Access Compliance Report

Public Rights-of-Way

(Curb Ramps)

| Intersection ID: 24242 | Main Street: BEVERLY_CREST_BV | Cross Street: PRESCOTT_POND_LN | Location: W |

| ADA ID: 893EBA6B89FF | Ramp Type: PerpDiag | Initial Pass/Fail: Fail | Overall Compliance: No |

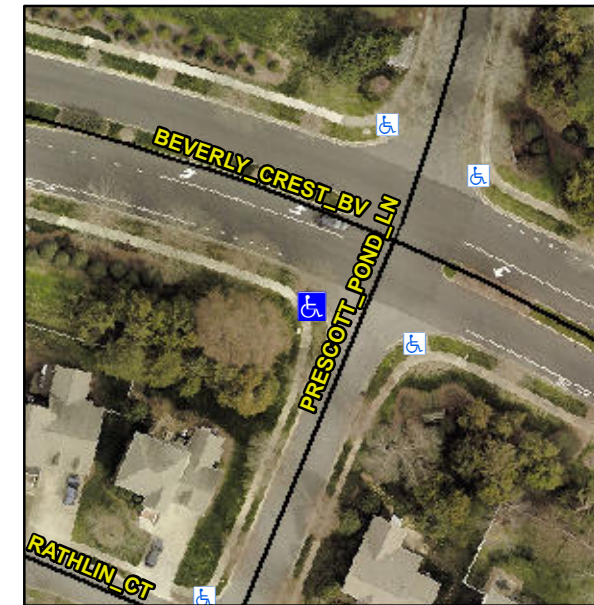
Not Found, R304.2.2, R304.5.3

| Compliance | Description | Data | Compliance | Description | Data |
|------------|-----------------------|-------|------------|-----------------------------|-------|
| N/A | Ramp Length (in) | 93.0 | No | Ramp Slope (%) | 8.7 |
| Yes | Ramp Width (in) | 48.0 | No | Ramp XSlope (%) | 5.9 |

Remove & Replace Curb Ramp With Two New Directional Ramps or Equivalent.
